**PLANNED UNIT DEVELOPMENT &
SUBDIVISION STAFF REPORT****Date: March 1, 2007****DEVELOPMENT NAME**The Woodlands at The Preserve Subdivision,
Resubdivision of Lot 59**SUBDIVISION NAME**The Woodlands at The Preserve Subdivision,
Resubdivision of Lot 59**LOCATION**3545 Rue Royal
(East side of Rue Royal, 800'± North of Rue Preserve)**CITY COUNCIL
DISTRICT**

CONTEMPLATED USEAmend Planned Unit Development (PUD) Approval to allow reduced
side yard setbacks.**TIME SCHEDULE
FOR DEVELOPMENT**

SITE PLAN

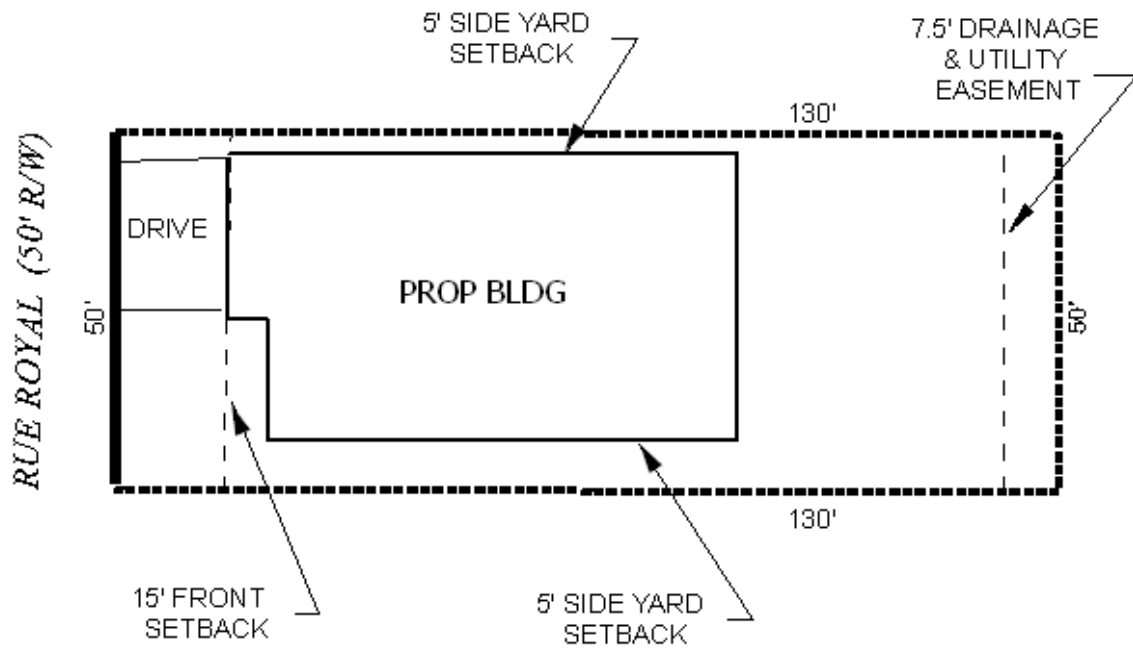
Site plans submitted for the construction of the dwelling illustrated 6'11" sited on the South side property line and 3'1" from the North side property line. However, "as built" plans illustrate the dwelling was constructed 5-feet from each side property line.

While allowing the construction of the residence seems fair and consistent under the circumstances, an amendment of the side yard seems to be the most practical, since demolition of the structure would seem an excessive remedy.

Planned Unit Development Based on the preceding, this application is recommended for Tentative Approval, subject to the following conditions: 1) revision of the site plan to illustrate the amendment of the side yard setbacks for Lot 59; 2) compliance with all municipal codes and ordinances; and 3) approval by the Building Official to determine the compliance with the building code.
